Index 641-020 Concrete CCTV Pole

COMMENTARY

COMMENTS AND RESPONSES

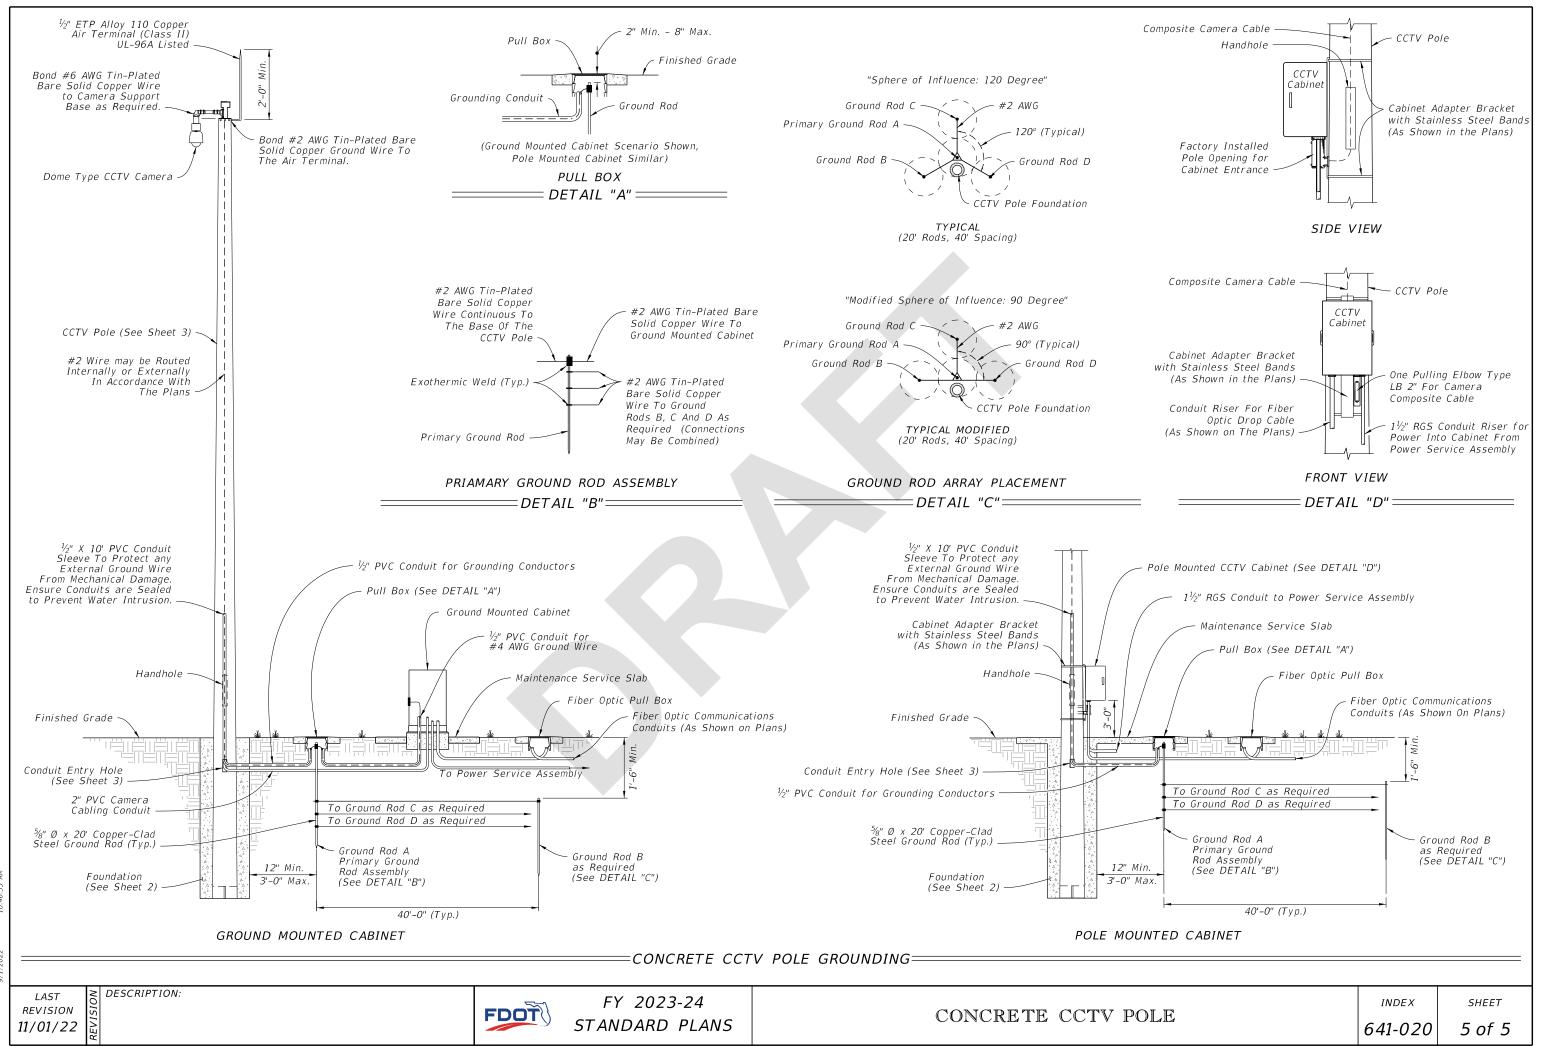
COMMENT: On sheet 6 of 6, maybe the location of the proposed maintenance slab can be shown to be cast against the shaft as opposed to being cast against the conduits. Also, will the Department consider making the maintenance slab of a standard thickness or will it need to be designed by a structural engineer.

RESPONSE: Agree the slab should be shown to be cast against the shaft and the conduits should be adjusted. The maintenance slab is intended to be 6" thick. This is shown in Index 676-010 but will be clarified. We will revise 641-020, 649-020 and 676-010 to show the slab thicknesses accurately.

CHANGE TO THE INDEX: Edit slab adjacent to shaft and adjust conduit. Edit pull boxes throughout the index to show 6" aprons to match maintenance service slabs.
